Town of Parker Community Development Department
Development Review Division
Attention: **Stacey Nerger**

Application Type: **Site Plan**
Status: **First Referral**
Application Name: **Lincoln Professional Park F1 - Preliminary Site Plan**
Case/AP#: **SP21-107**
Referral Received: September 22, 2021
Comments Due: October 20, 2021

Review date: **October 14, 2021**
Plan reviewer: **Randall L. Capra**, rcapra@parkeronline.org
Phone: 303.805.3163

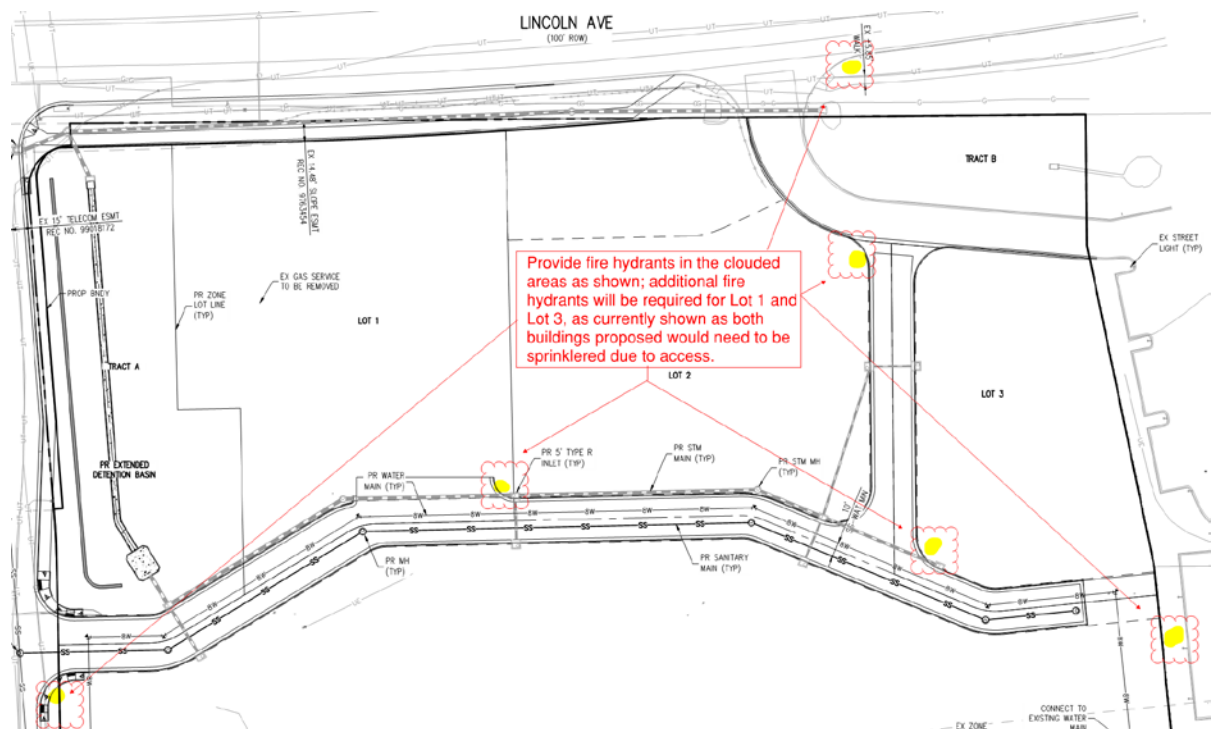
UNRESOLVED ISSUES/COMMENTS

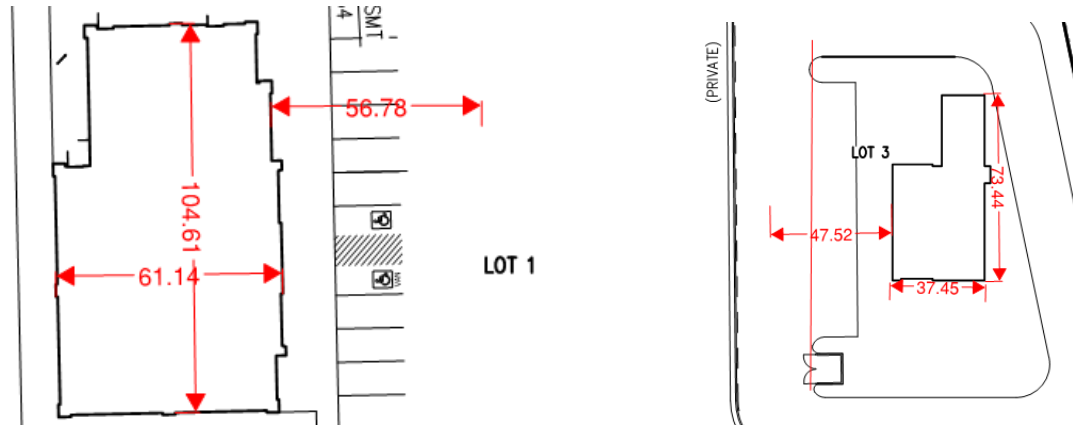
8. **Sheet 3 Overall Utility:** The overall utility drawings are incomplete; the plan set does not address fire hydrant locations for the spine roads proposed. The applicant shall address this issue and fire hydrants will be required in the following locations while noting that additional hydrants will be required on the internal lots depending upon access and use (the gas station will be required to be sprinklered as will Lot 3... as currently shown):

- The entry off of Dransfeldt Road on to Road A
 - The entry off of Lincoln Ave and the current Private Drive
 - Road A (required extension) into Lot 1 Filing No.2 Peaslee Subdivision at Road A and Lot 1

- At the corner of Road B and the Private Drive
 - At the corner of Road A and Road B
 - At the entry of the gas station off of Road A

See below for locations required:
